ORDINANCE NO. 2020-29

AN ORDINANCE OF THE CITY TOWN OF FAIRVIEW, TEXAS, ADOPTING THE 2018 EDITION OF THE INTERNATIONAL RESIDENTIAL CODE, AMENDING SPECIFIC SECTIONS; REPEALING ORDINANCE NUMBER 2014-39 WITH CERTAIN EXCEPTIONS AND ALL AMENDMENTS; PROVIDING A PENALTY CLAUSE; PROVIDING A SAVING CLAUSE; PROVIDING A SEVER-ABILITY CLAUSE; AND PROVIDING AN EFFECTIVE DATE.

****Figure R602.6.1; delete the figure and insert the following figure:**

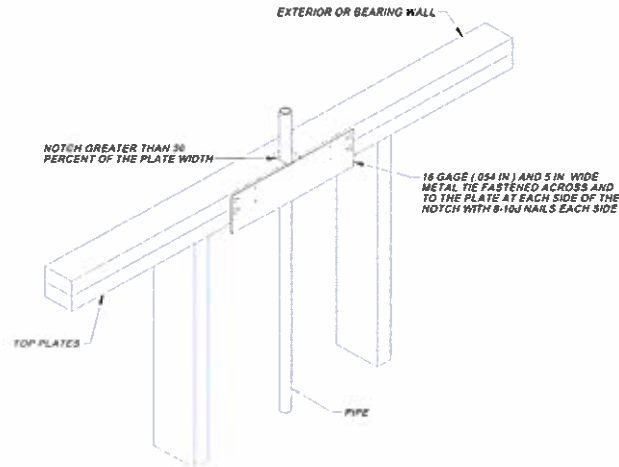
R602.6.1 Drilling and notching of top plate. When piping or ductwork is placed in or partly in an exterior wall or interior load-bearing wall, necessitating cutting, drilling or notching of the top plate by more than 50 percent of its width, a galvanized metal tie not less than 0.054 inch thick (1.37 mm) (16 Ga) and ~~4-1/2 inches (38) mm~~ 5 inches (127 mm) wide shall be fastened across and to the plate

at each side of the opening with not less than eight 10d (0.148 inch diameter) having a minimum length of 1 ½ inches (38 mm) at each side or equivalent. Fasteners will be offset to prevent splitting of the top plate material. The metal tie must extend a minimum of 6 inches past the opening. See figure R602.6.1. {remainder unchanged}

(Amendment to 2015 IRC carried forward to 2018 IRC also provides additional assurance of maintaining the integrity of the framing by spreading the nailing pattern.)
